Access Compliance Report Public Rights-of-Way (RR Crossings)

Intersection ID: 10032938	Main Street: NEW_BERN_ST	Location: N/A
ADA ID: 2E9D4843096D	Overall Compliance: No	Severity Score: 0.0
Codes/Mitigation Info/Possible Solution		Field Measurements/Component Compliance

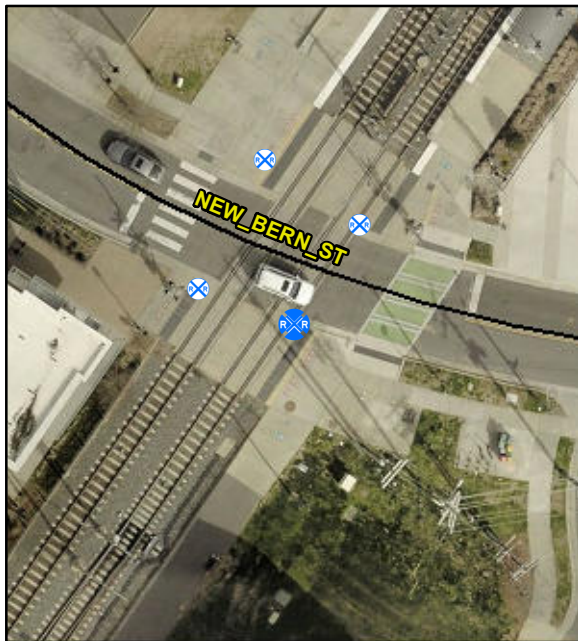
Remove & Replace Detectable Warning System. Provide Pedestrian Gate. Remove & Replace Walking Surface Adjacent to Rail.

R302.7.4, R305.2.5

Compliance	Description	Data
Yes	DWS Provided?	Yes
Yes	DWS Contrast?	Yes
Yes	DWS Width (in)	Yes
Yes	DWS Length (in)	36.0
No	DWS Offset (in)	28.5
No	Pedestrian Gate?	No
N/A	DWS Outside Gate?	N/A
N/A	Rail Type?	LightRail
No	Flangeway Gap (in)	3.0
Yes	Sidewalk Width (in)	56.5
